P&Z CASE # SP2022-043 P&Z DATE 09/13/2022 CC DATE \_\_\_\_\_ Approved/Denied

PROJECT NUMBER: SP2022-043  
PROJECT NAME: Site Plan for 607 White Hills Drive  
SITE ADDRESS/LOCATIONS: 607 WHITE HILLS DR

CASE CAPTION: Discuss and consider a request by Paul Cragun of Cumulus Design on behalf of Campfire Shops, LLC for the approval of a Site Plan for a Carwash, Restaurant, and Commercial/Retail Shopping Center on a 2.003-acre parcel of land identified Lot 4, Block A, Wal-Mart Super Center Addition, City of Rockwall, Rockwall County, Texas, zoned Commercial (C) District, situated within the IH-30 Overlay (IH-30 OV) District, situated along the east side of White Hills Drive south of Suncrest Drive, and take any action necessary.

DEPARTMENT	REVIEWER	DATE OF REVIEW	STATUS OF PROJECT
PLANNING	Bethany Ross	08/26/2022	Approved w/ Comments

SITE PLAN		
ROCKWALL RETAIL		
607 WHITE HILLS DRIVE		
WAL-MART SUPER CENTER ADDITION, BLOCK A, LOT 4		
CITY OF ROCKWALL, ROCKWALL COUNTY, TEXAS		
CITY CASE NUMBER	DATE	SHEET
	08/03/22	SP

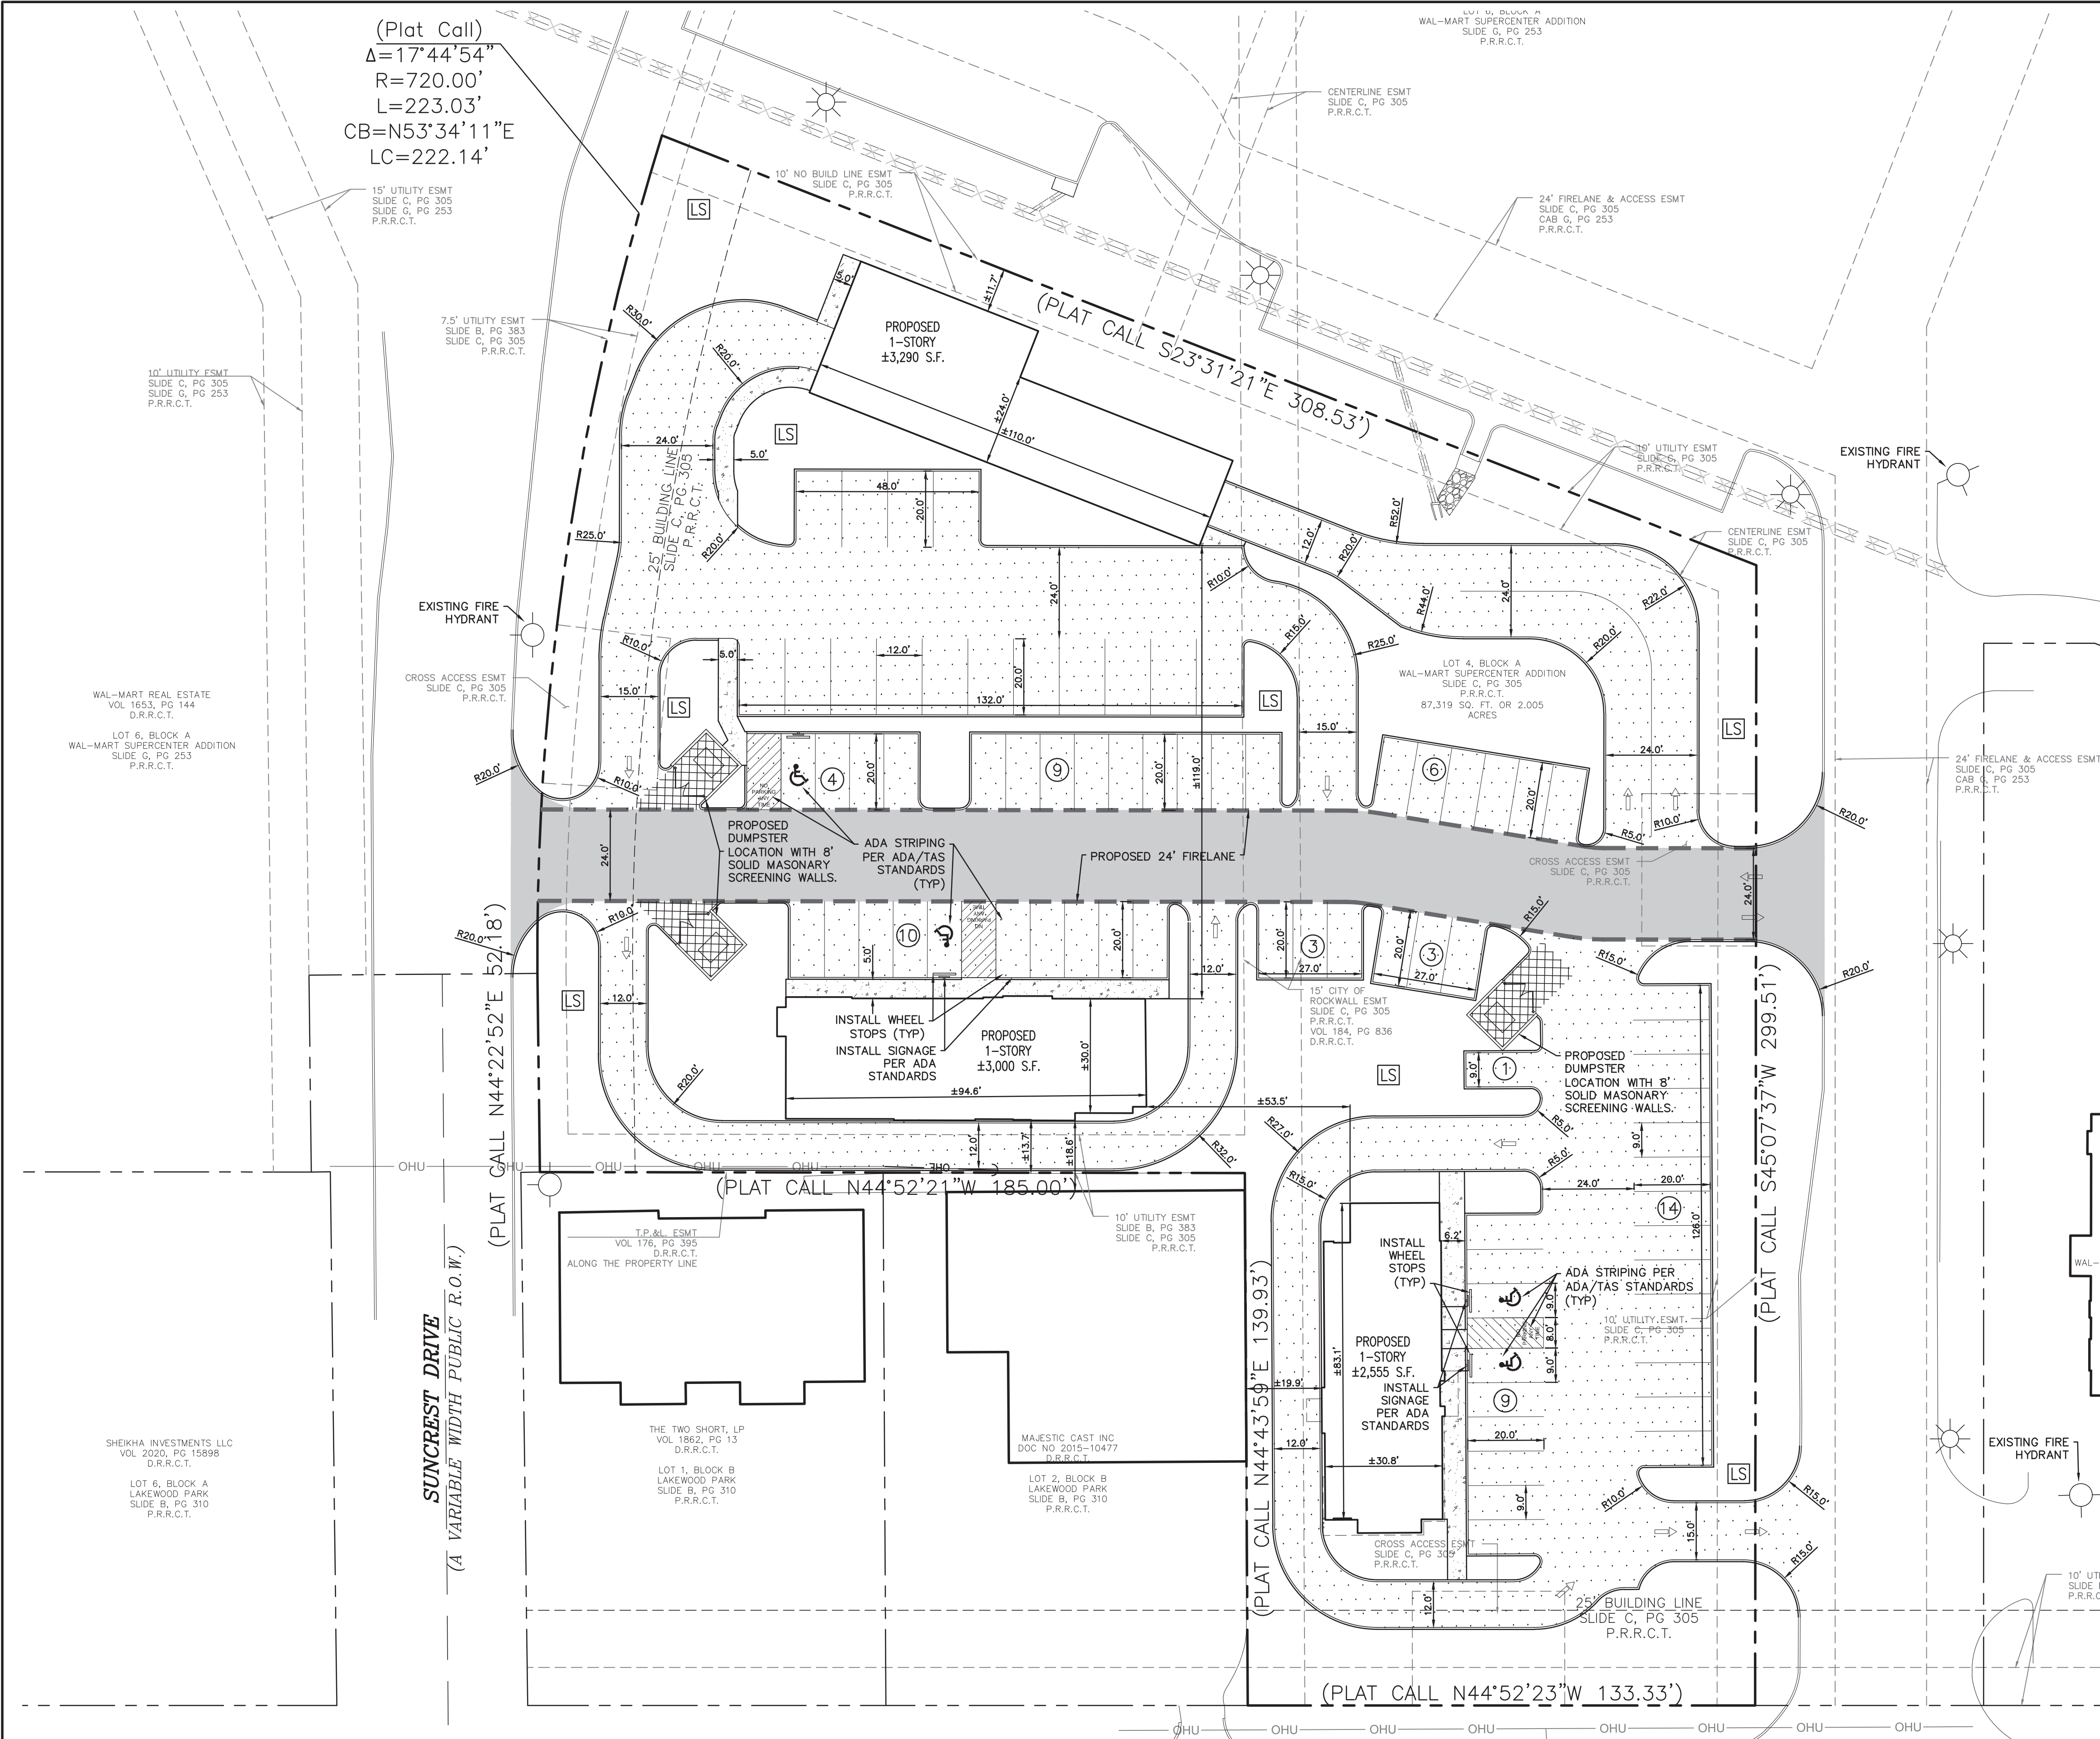
(1) Indicate all utilities both existing and proposed on the site plan. (Subsection 0.04.B, of Article 11, UDC)

(2) Pad mounted utility equipment, and air conditioning units, shall be screened from horizontal view from any adjacent public street and from any adjacent property. Utility equipment and air conditioning units shall be screened utilizing plantings berms, or walls matching the main structure. (Subsection 01.05.C, Article 05, UDC)

(4) Provide an exhibit of the dumpster enclosure. Trash/Recycling Enclosures shall be four (4) sided. These receptacles shall be screened by a minimum eight (8) foot, solid masonry dumpster enclosure that utilizes the same masonry materials as the primary building and incorporates an opaque, self-latching gate. These enclosures shall be located to the side or rear of the primary building, and shall not front on to a public right-of-way. Every effort shall be made to reduce the visibility of these structures utilizing landscaping and/or the building. (Subsection 06.02.D.7, Article 05, UDC)

- (5) Indicate if there will be vacuum bays for the car wash and show them on the site plan.

LANDSCAPE PLAN

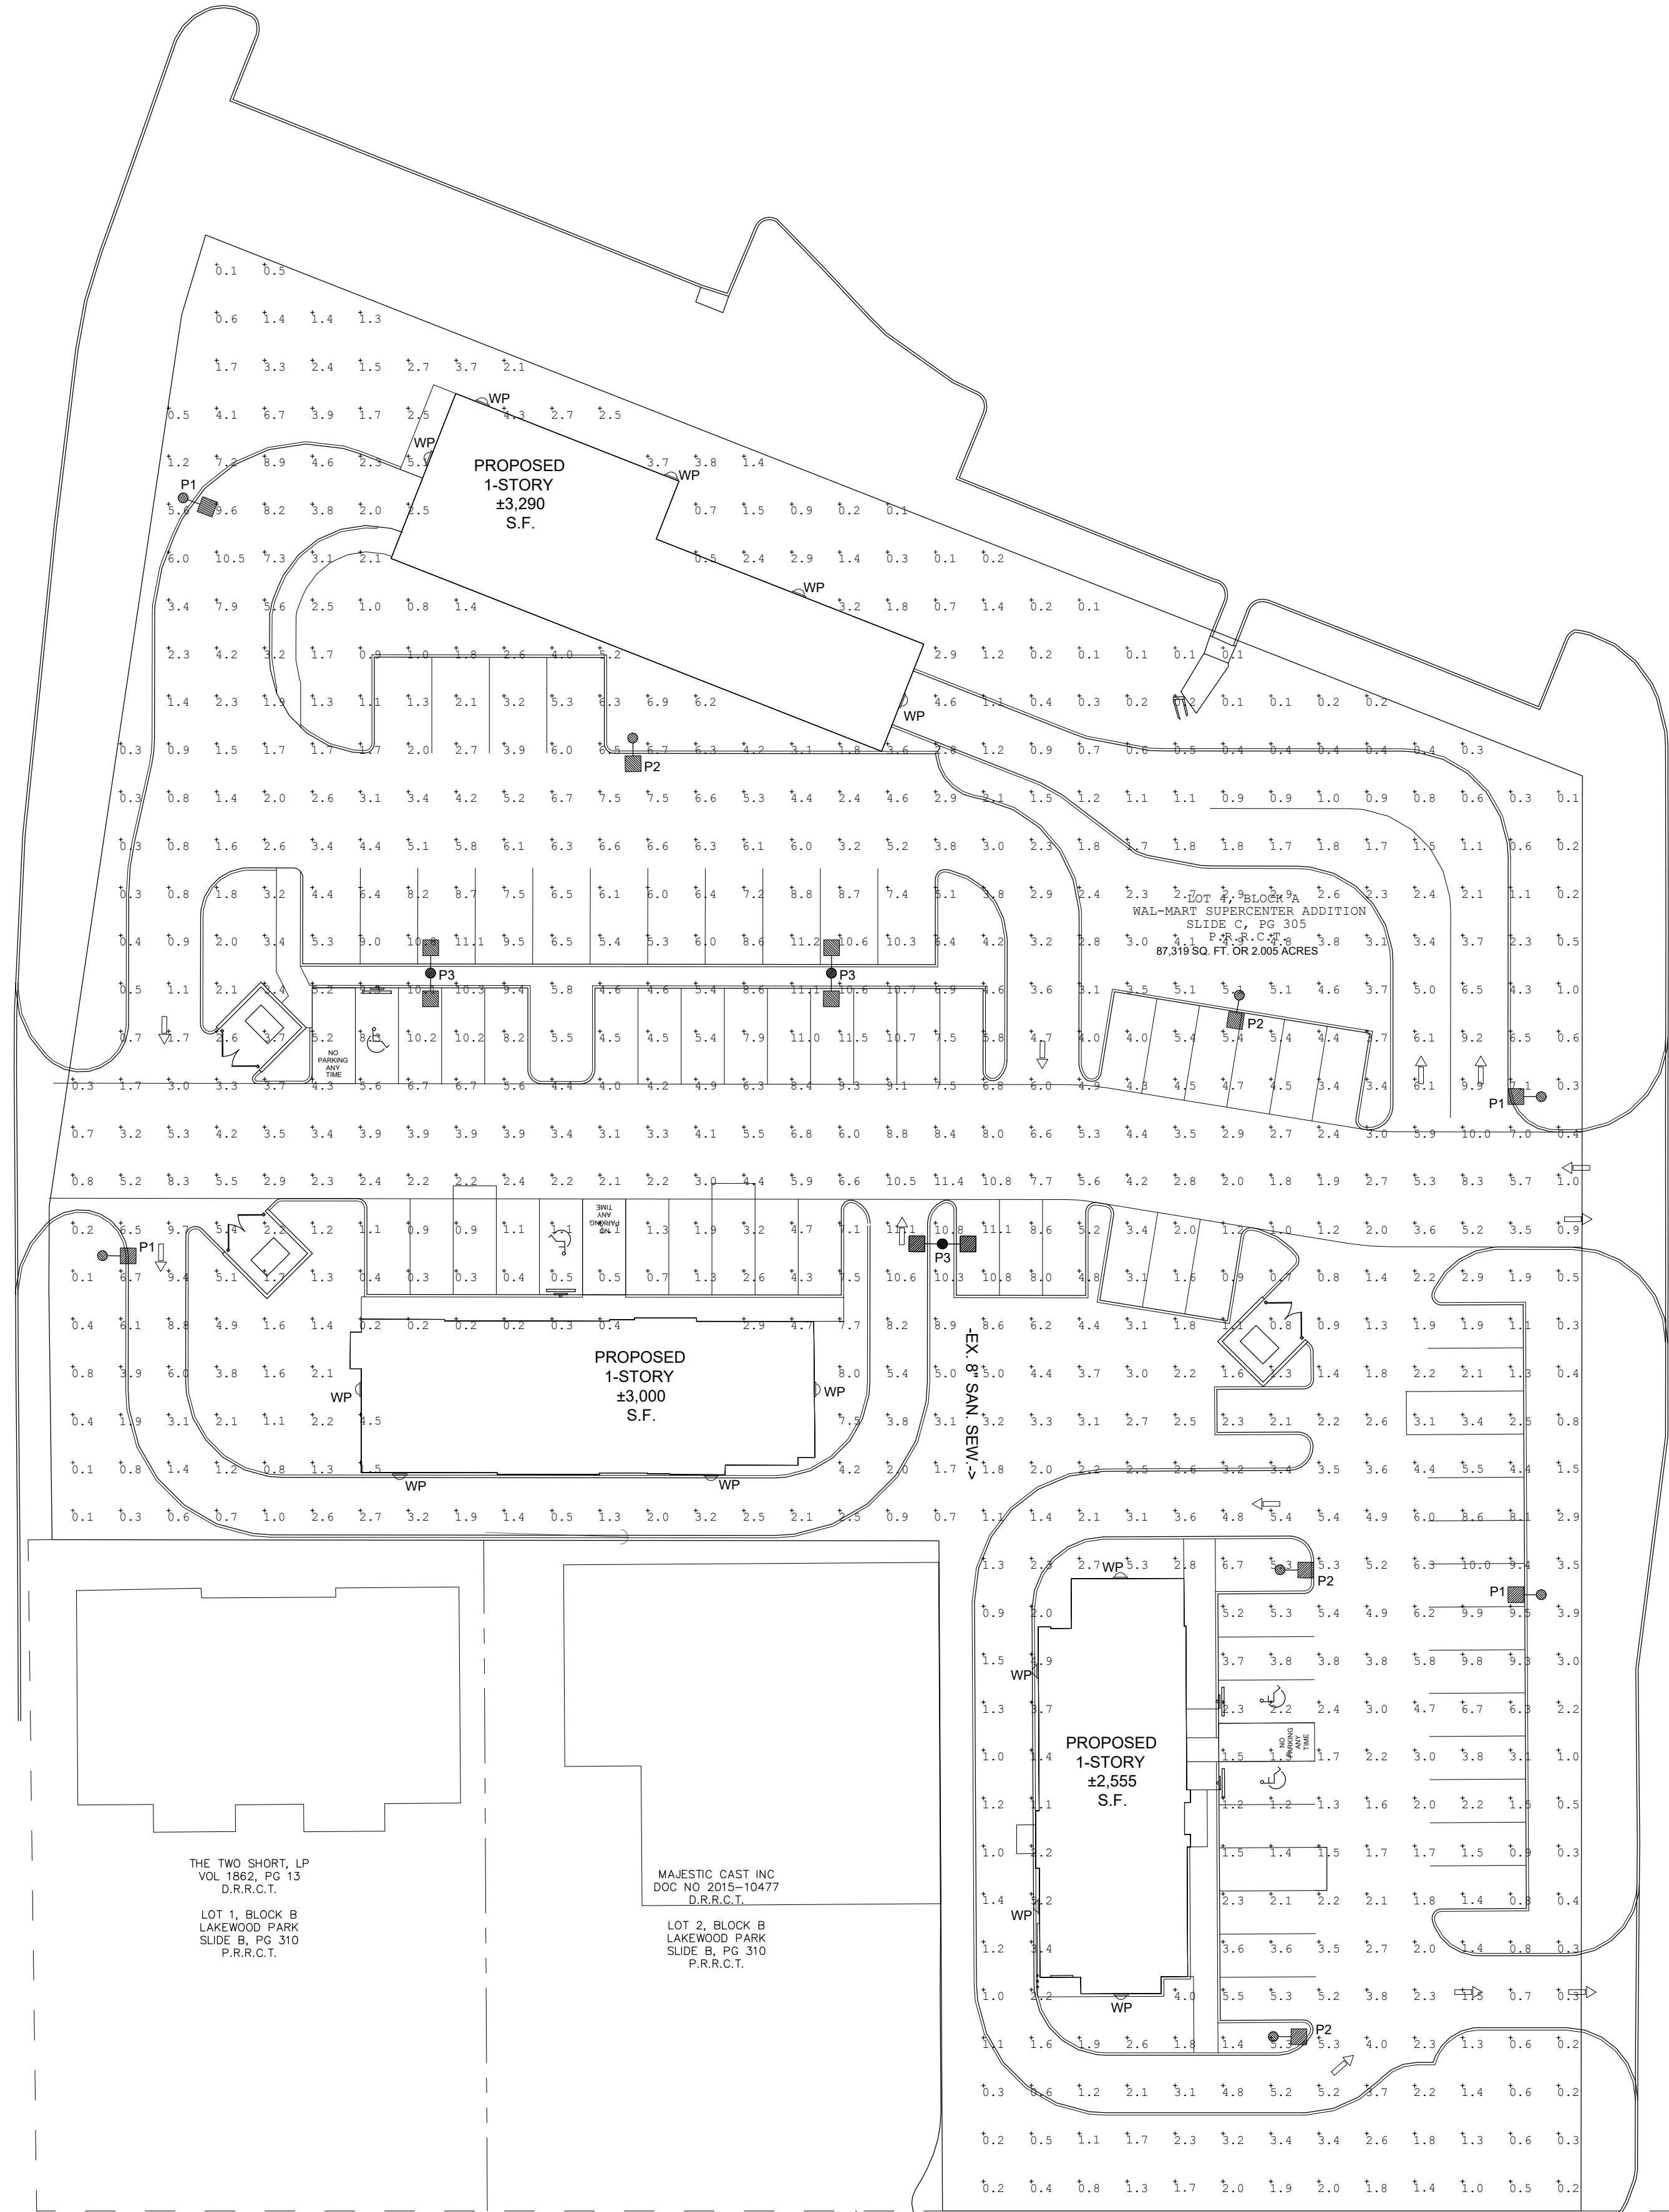
- (1) Provide a 10' landscape buffer along the north and south property lines of the site. All landscape buffers shall incorporate ground cover, a built-up berm and shrubbery along the entire length of the frontage. Berms and shrubbery shall have a total minimum height of 30-inches. In these areas a minimum of one (1) canopy tree and one (1) accent tree shall be incorporated into the landscape buffer per 50-linear feet of frontage. Clustering of trees shall be permitted as long as all required trees are situated within the landscape buffer. (Subsection 05.01.B.1, Article 08, UDC).

- (9) Identify visibility triangles for all driveway intersections and public streets. (Subsection 01.08, of Article 05, UDC)
- (10) Trees must be planted five feet from water, sewer, and storm sewer lines. (Subsection 05.03.E, of Article 08, UDC)

- (11) Ground mounted equipment and air conditioning units shall be screened utilizing plantings, berms, walls matching the main structure, or an architectural feature that is integral to the building's design. (Subsection 01:05.C, Article 05, UDC)
